Technical change to HDC RailMate

PCN-number:	PCN-PB72-20190430-00-A
Date of publishing:	2019, April 30
Duration of validity:	Until further notice
Revision number:	00-A

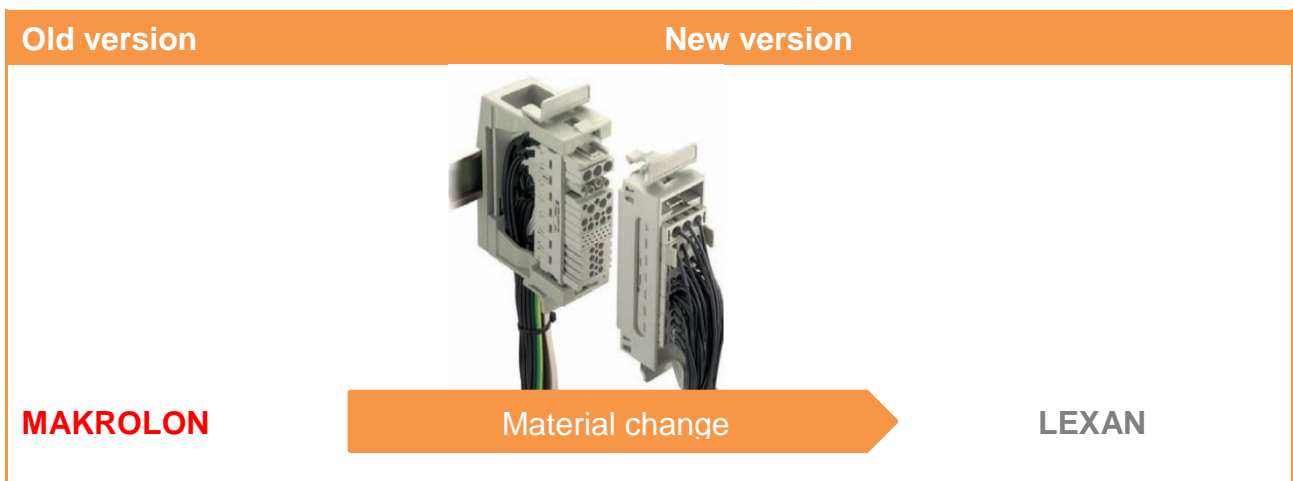
The HDC rail mounting system "RailMate" was previously made of Makrolon.

In the future, all plastic components of the RailMate system will be made of Lexan.
 The components made of Lexan appear in their colour a bit lighter than before.

It is now possible to achieve a uniform, homogeneous colour scheme. The individual components always have the same uniform, homogeneous colouring.
